ADDENDUM NUMBER 1

DATE: March 6st, 2024

PROJECT: St. Clair County DTNW – Facility Renovation

PROJECT NUMBER: 0230-0002

2 ENLARGED FIRST FLOOR PLAN - ENTRY
A401 3/8" = 1'-0"

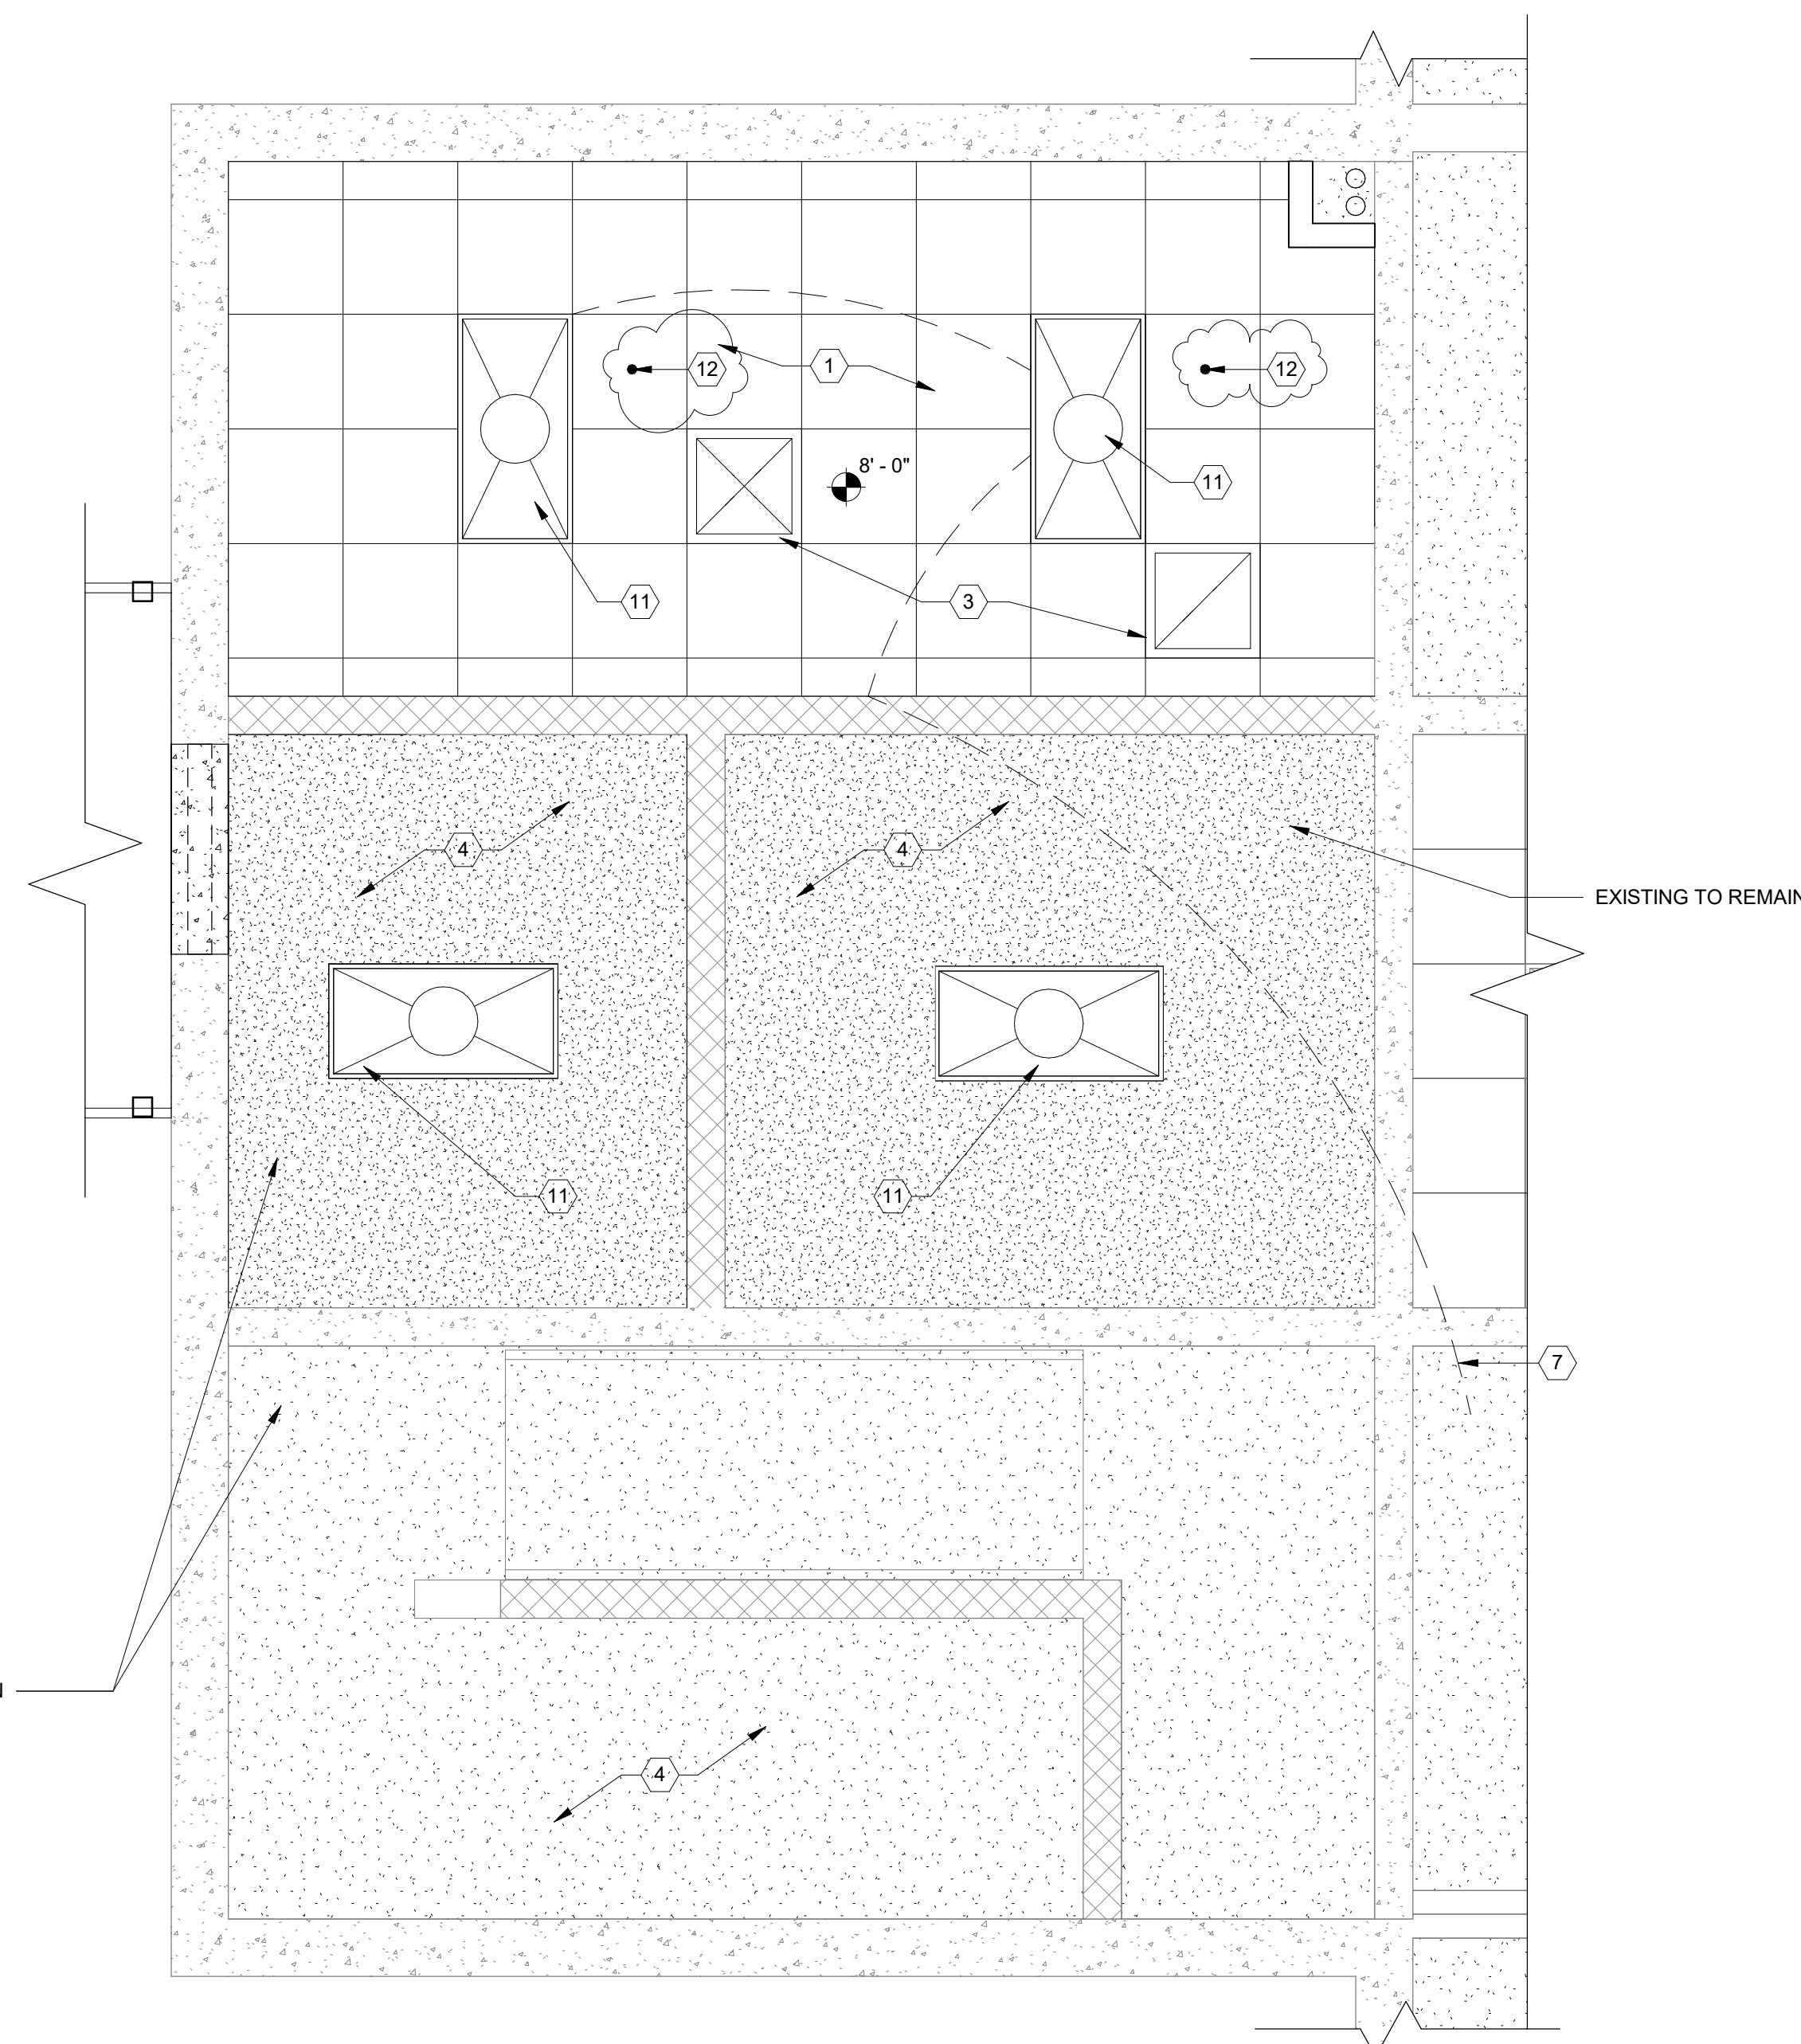
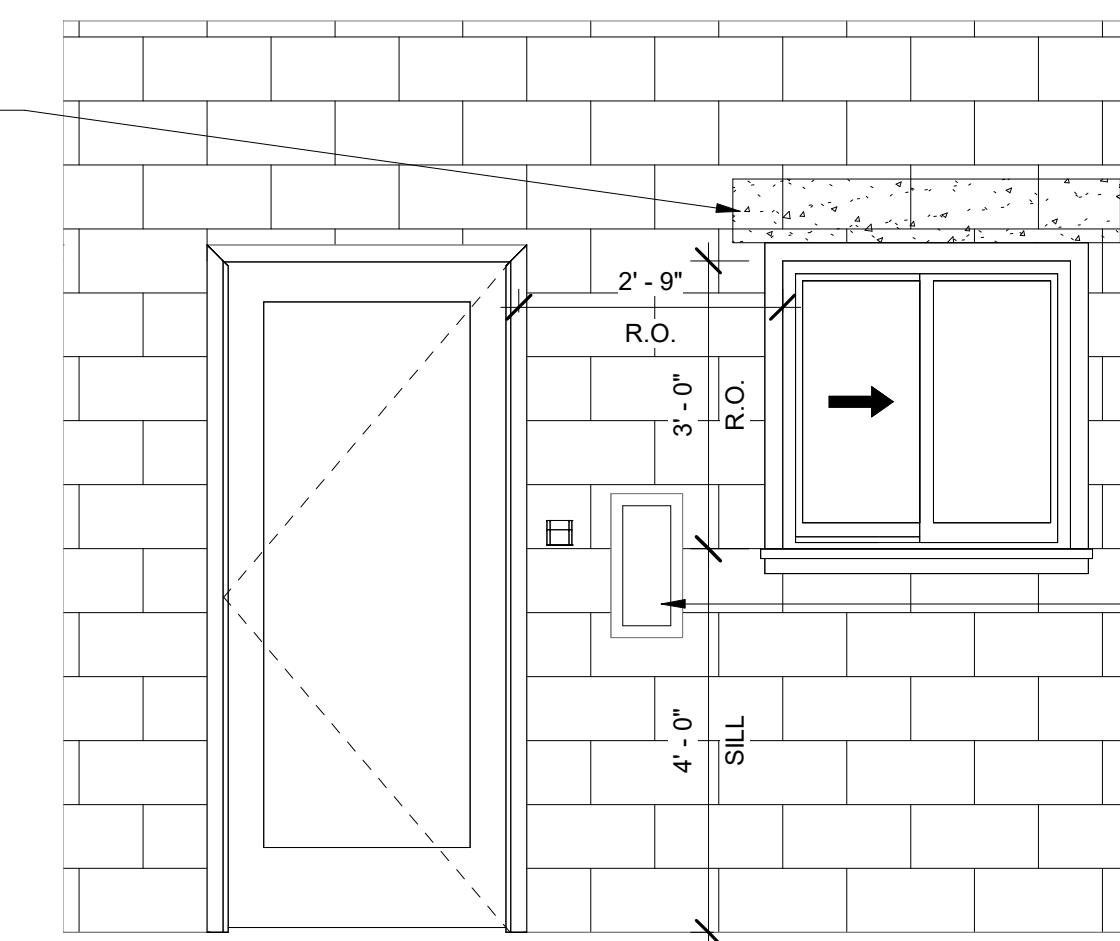
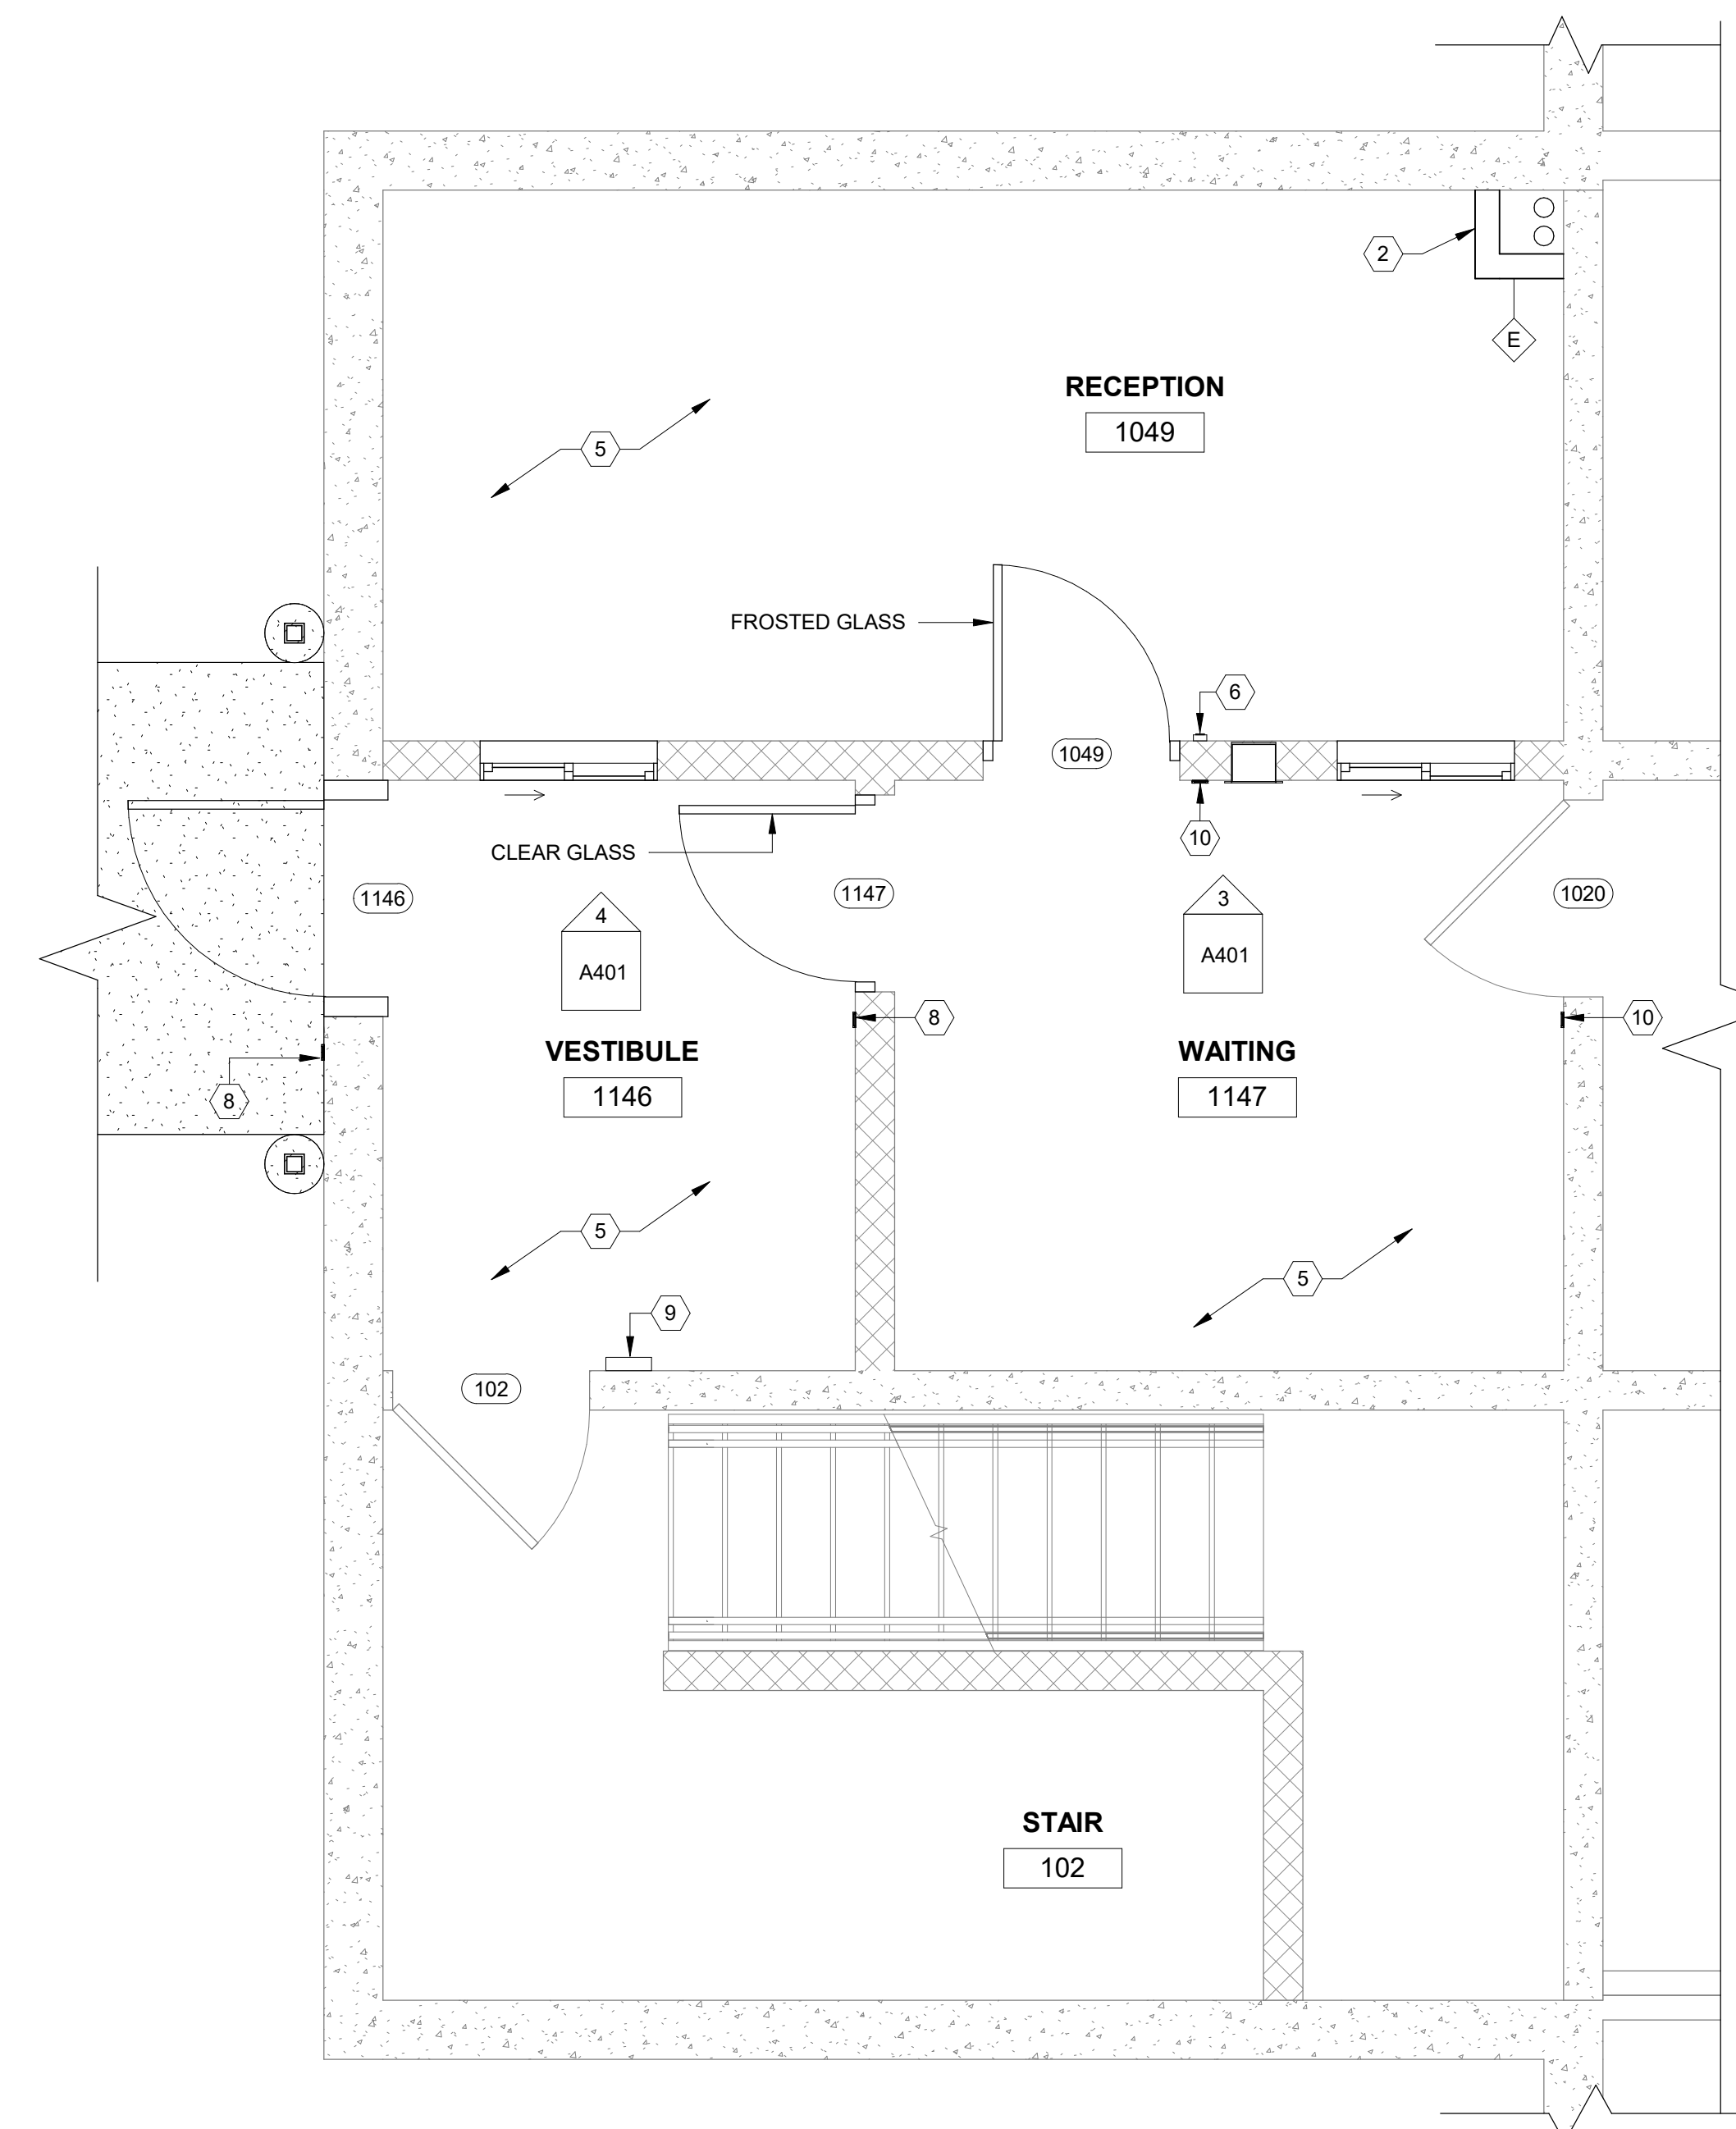
Q: Drawing A-401 Note #8, #9 & #10 indicates access controls, will the card reader and low voltage be provided by the owner, and we are just responsible for the raceways and boxes?

Q: Drawing A-401 indicates the glass for door 1049 to be frosted, is this to a window film or are you requesting the glass to be frosted?

2. SHEET A031:
 - a. Updated Spec.
3. SHEET A102:
 - a. Updated Floor Plan Keynotes.
4. SHEET A401:
 - a. Updated Keynotes and Reflected Ceiling Plan.
5. SHEET A403:
 - a. Updated Detail #5.

A: By owners' vendor, Conti

A: Frosted Glass, no films.

5 WALL PANEL SEAL DETAIL
A403 1" = 1'-0"

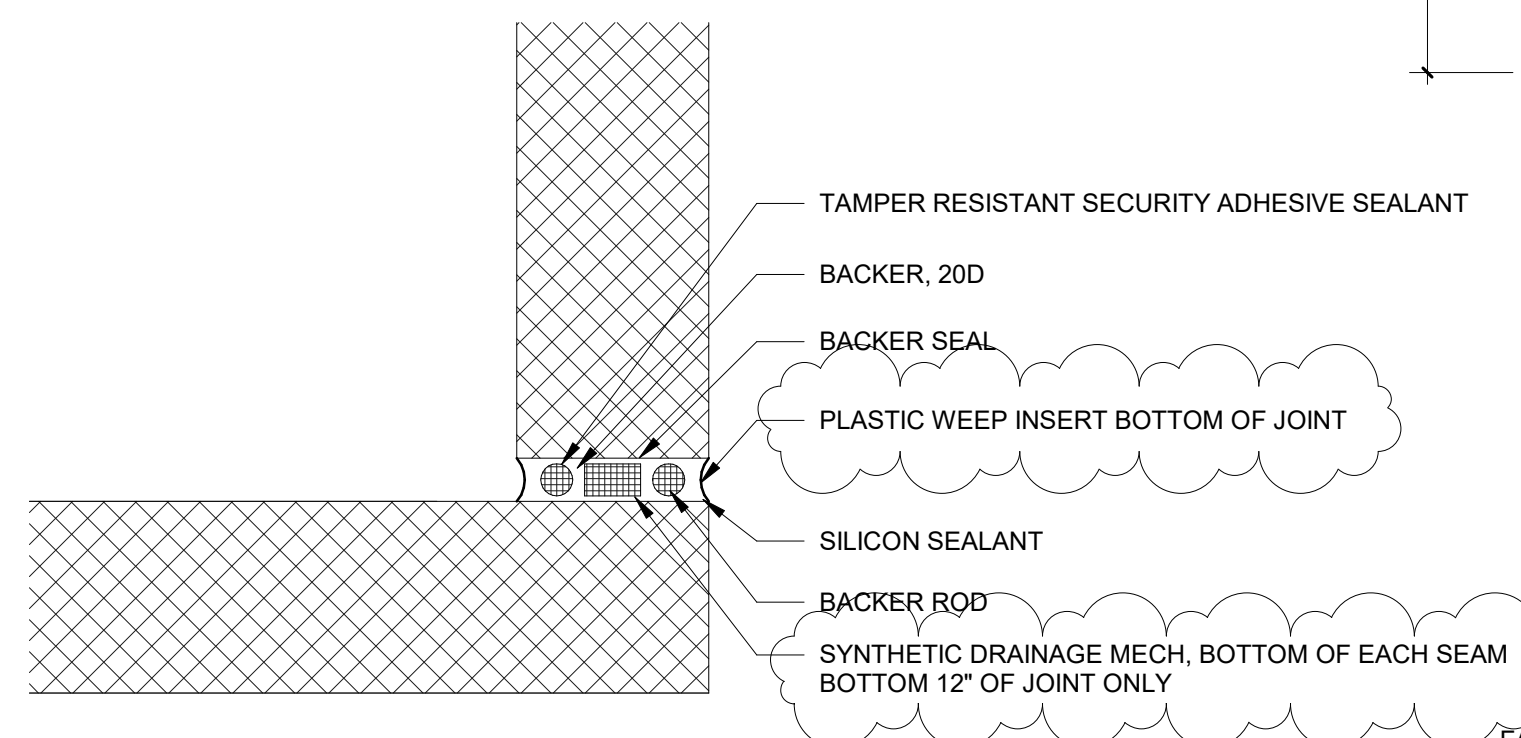
Q: Per sheet A101, each corner has a blow-up detail, 5/A403. This detail shows the removal and replacement of the sealants. When looking on google earth, there are quite a few joints on the building, is it the owner's intent to remove and replace the corner sealants or all panel sealants? Please clarify.

A: Only the panels joint, at the corners, as shown on A101 with be replaced.

NOTE:
1. TAMPER RESISTANT SECURITY ADHESIVE SEALANT TO RE-USE ON THE INTERIOR ONLY
2. REMOVE ALL SEALANT FROM JOINT FROM FLOOR SLAB TO PARAPET CAP

DOOR SCHEDULE

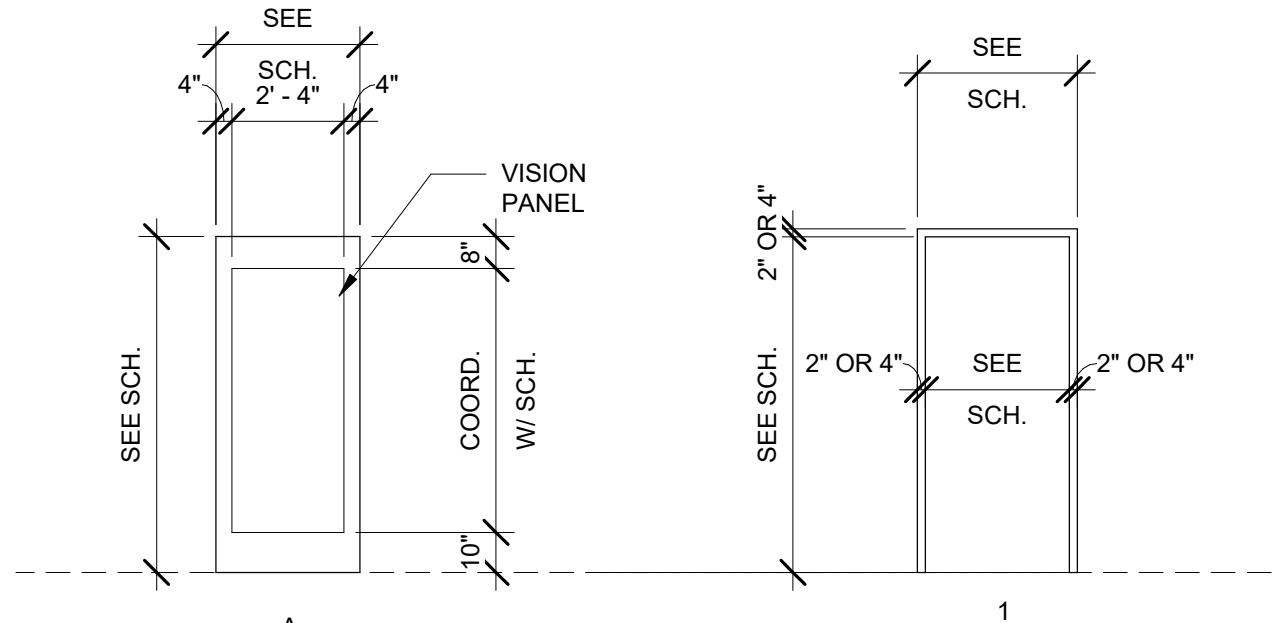
Q: Drawing A-601- indicates Door 1049, 1146, & 1147 as new Aluminum Doors and Frames, please provide a specifications & hardware set for these doors.

6. SHEET A601:
 - a. Updated Door Schedule.

A: See sheet A031.
